Service Bulletin Foot Plate Design Change	
Effective Date: April 7, 2017	Models Affected: S5X-01 (CS08), S5X (CS11), S3x-01(CS15)	Bulletin Num.
Prepared by: Eric Chen

Table 1: The Foot Plate Service Kit

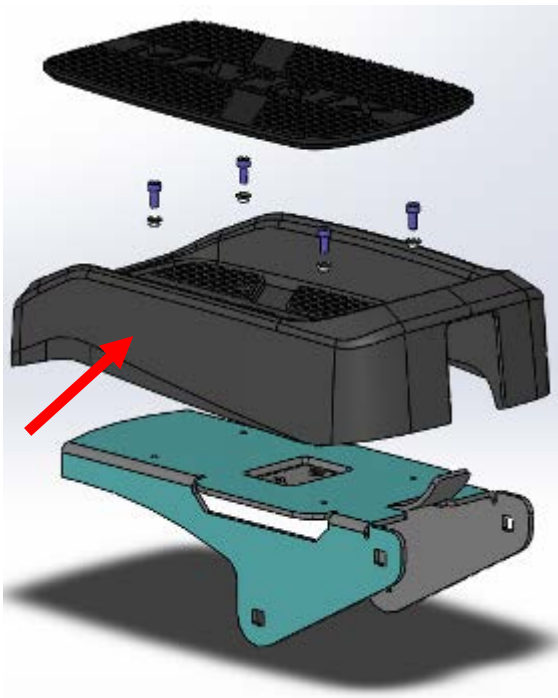
The plastic boss at the bottom of the plastic foot plate may break.

The plastic boss of foot plate is not strong.

Old

New

1. JHT has designed a new foot plate and pedal set to avoid possible breakage (used in production April 2017). See Table 1 & 2.
2. In the field, if an old foot plate on a unit produced before April 2017 must be replaced, please order the new service kit (SAP #1000408091; includes both left and right foot plate sets). See Table 1 & 3.
3. The new application is available starting April 7, 2017.

New design for field only- service kit #1000408091
(for units produced **before** April 7, 2017)

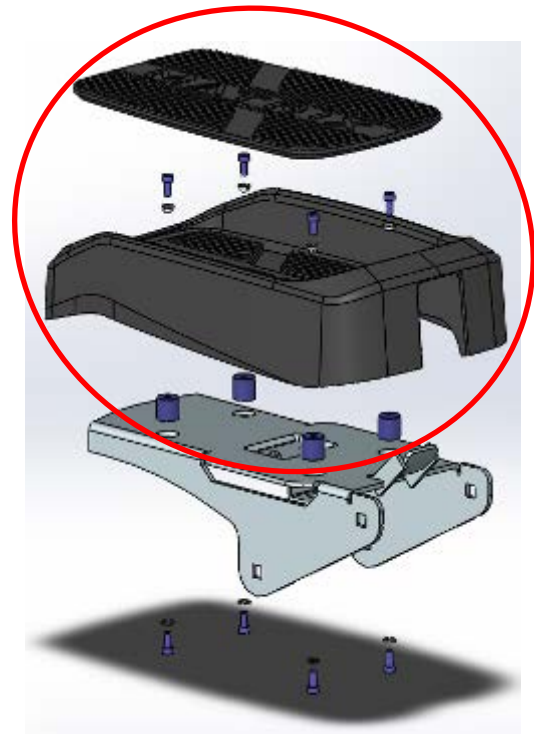
New design for production line and field
(for units produced **on or after** April 7, 2017)

Installing the new foot plate (For units produced **before** April 2017)

1. Put 4 new spacers on the old pedal set.

2. Attach the spacers to the pedal set using 4 screws and 4 washers (use the original screws and washers which were removed from the unit).

3. Use 4 new screws and 4 new spacer rings to attach the new foot plate to the old pedal set.

4. Put the new cushion on the new foot plate.
